SUBJECT: Provides supplemental info to 860226 application to amend
 License NpF-21 re Cycle 2 reload. Use of two separate sets
 for two-loop operating limits for fuel types & separate set
 for single loop proposed. Mark-up Tech Specs encl.

May 22, 1986
G02-86-477

Subject: NUCLEAR PLANT NO. 2
OPERATING LICENSE NPF-21, REQUEST FOR AMENDMENT
TO TECHNICAL SPECIFICATIONS - RELOAD LICENSE
AMENDMENT (CYCLE 2), SUPPLEMENTAL INFORMATION

Maximum Average Planar Linear Heat Generation Rate (MAPLHGR) Versus Average Planar Exposure Initial Core Fuel Type 8CR183
Figure 3.2.1-4

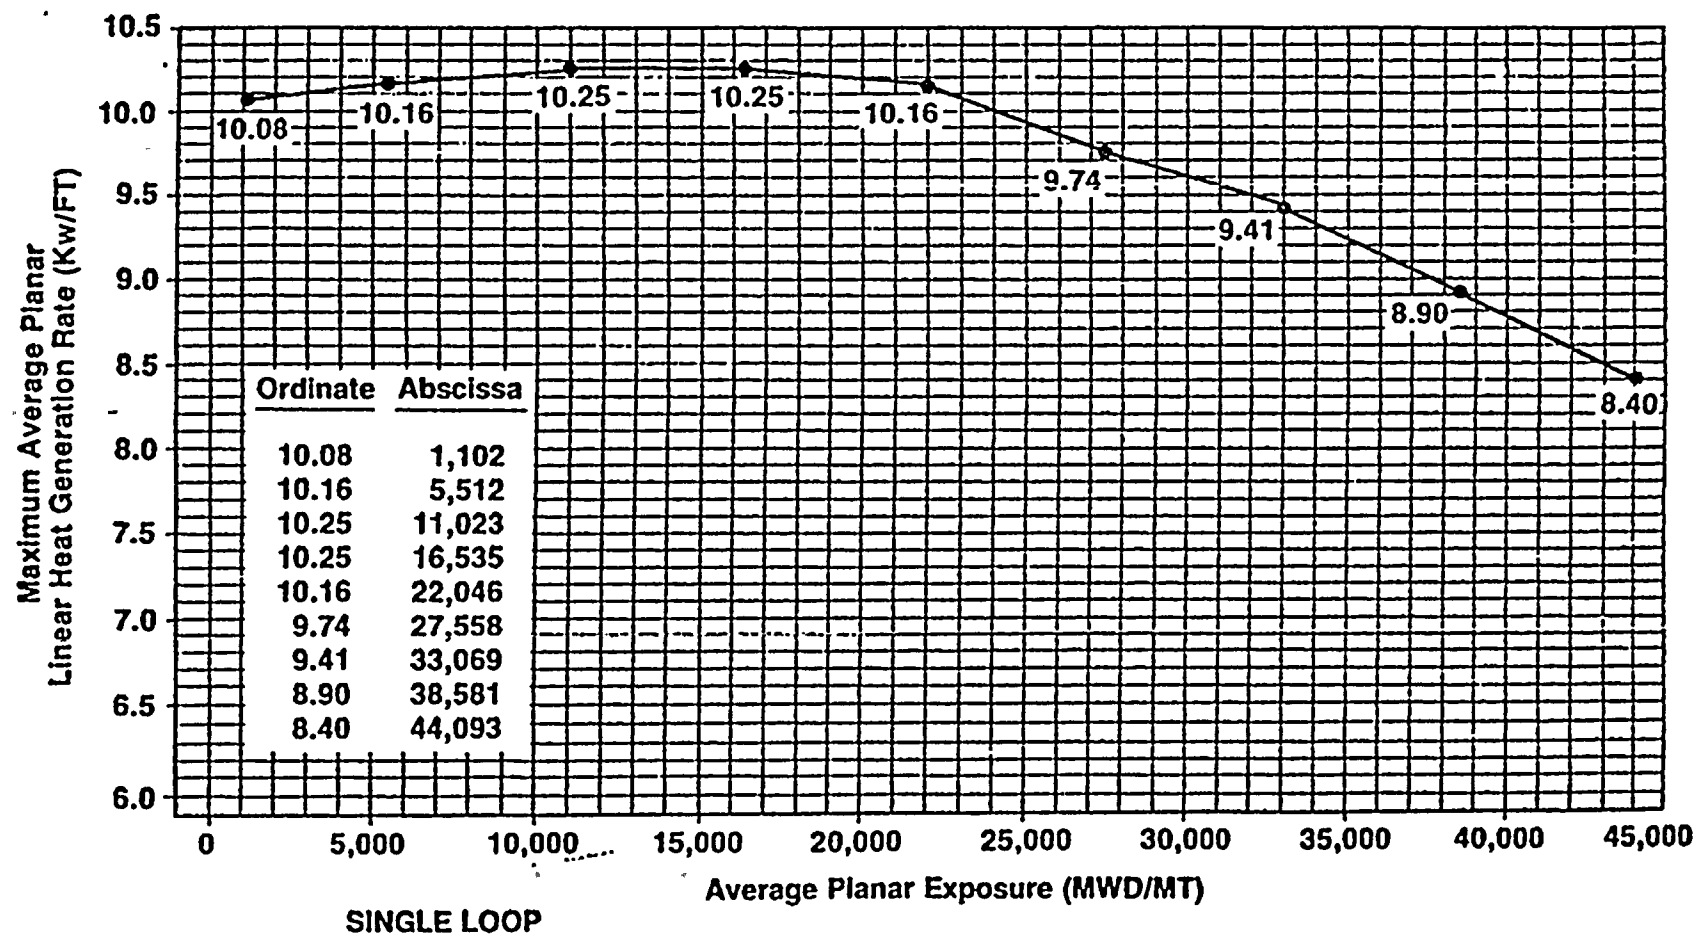
3.2.1 All AVERAGE PLANAR LINEAR HEAT GENERATION RATES (APLHGRs) for each type of fuel as a function of AVERAGE PLANAR EXPOSURE shall not exceed the limits shown in Figures 3.2.1-1, 3.2.1-2, and 3.2.1-3. The limits of Figures 3.2.1-1, 3.2.1-2, and 3.2.1-3 shall be reduced to a value of 0.84 times the two recirculation loop operation limit when in single recirculation loop operation for single loop operation are shown in Figures 3.2.1-4, 3.2.1-5, and 3.2.1-6. ^{for GE fuel and average bundle exposure for ENC fuel}

With an APLHGR exceeding the limits of Figure 3.2.1-1, 3.2.1-2, ~~3.2.1-3~~, 3.2.1-4, 3.2.1-5, or 3.2.1-6, initiate corrective action within 15 minutes and restore APLHGR to within the required limits within 2 hours or reduce THERMAL POWER to less than 25% of RATED THERMAL POWER within the next 4 hours.

4.2.1 All APLHGRs shall be verified to be equal to or less than the limits determined from Figures 3.2.1-1, 3.2.1-2, ~~and 3.2.1-3~~ 3.2.1-4, 3.2.1-5, and 3.2.1-6.
